HORSHAM DISTRICT COUNCIL CONSULTATION

TO:	Horsham District Council – Planning Dept
LOCATION:	Land North of East Street Rusper West Sussex
DESCRIPTION:	Application for Approval of Details Reserved by Conditions 3,4,5,8,9,10,11 and 12 to approved application DC/25/0523
REFERENCE:	DISC/26/0080
RE-CONSULT:	1 st set of comments in black 2 nd set of comments in blue 3 rd set of comments in green
RECOMMENDATION:	Condition 5: More Information / Modification No Objection Conditions 8, 9, 10, 11: No comments Condition 12: More Information No objection

[left: DISC/26/0080 Combined Services, right: DC/25/0523 Landscape Masterplan]

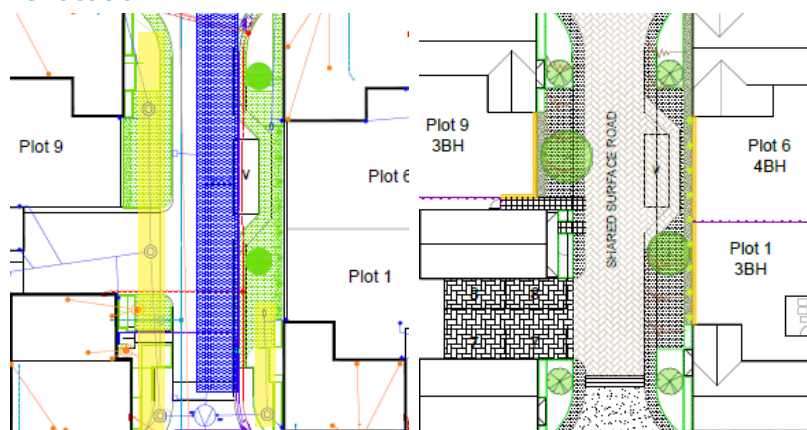
1. The combined services drawing has not been coordinated with the landscape proposals and thus we note areas of conflict with proposed trees. These plans must be coordinated and altered to ensure both strategies can be delivered, avoiding trees located within easement zones. Please note that the proposed trees are key to the general amenity of the development and serve as landscape mitigation to retain the wooded character of the area.

The combined services drawing has now been coordinated with landscape proposals, with thanks. While areas of conflict are now resolved, 11no. trees are absent from the scheme. Slight variation in proposed locations is acceptable, however the full number of proposed trees approved under DC/25/0523 is expected to be delivered. Detailed information is not expected at this stage, however given the site constraints and proximity to underground services, details of root barriers and root cells are expected to be provided under Condition 7 to ensure successful establishment and long-term retention.

One area of potential conflict is however noted in the location below. Please adjust the drainage runs (highlighted in yellow) to ensure the previously proposed trees can still be delivered in this location.

11no. trees have been reinstated, with thanks. One instance of a root barrier is noted, however further provision in addition to root cells, as above, will be expected under Condition 7. Closed.

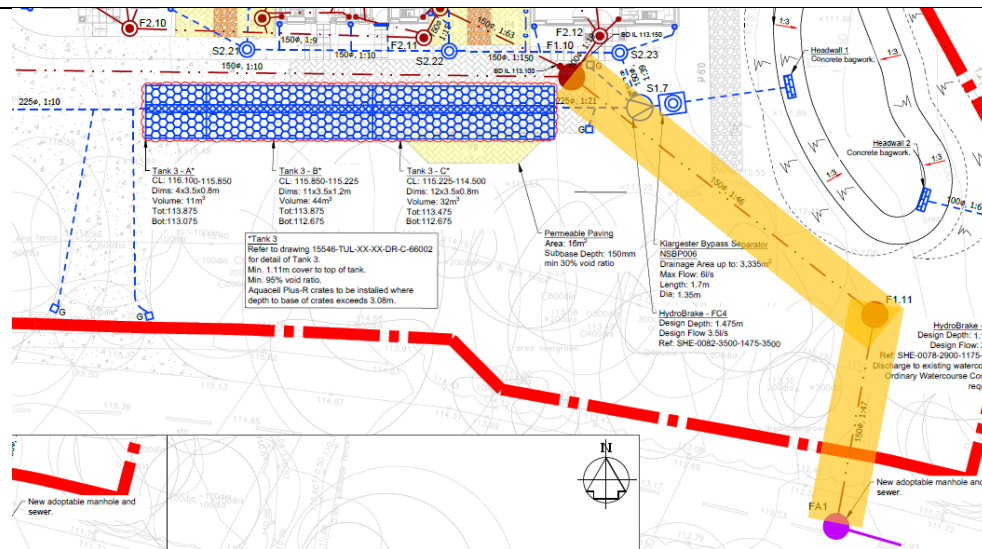
2. We note discrepancy between the combined services drawing and the drainage strategy approved under DC/25/0523. Clarification is requested.
Discrepancy remains, highlighting the significant reduction in permeable paving in particular. Nonetheless, no further concerns remain from a landscape point of view, subject to the successful delivery of the approved landscape strategy under DC/25/0523. Closed.
3. As above, a constructed manhole is now proposed within the RPA of a mature oak, T55. This must be re-located outside the Tree Protection Fencing.

Minor adjustment made, with thanks. Further adjustment is recommended, if possible or practicable to do so.

Amended, with thanks. However, it is noted that the updated drainage strategy results in development beyond the proposed tree protection fencing (see highlighted foul run in yellow, below).
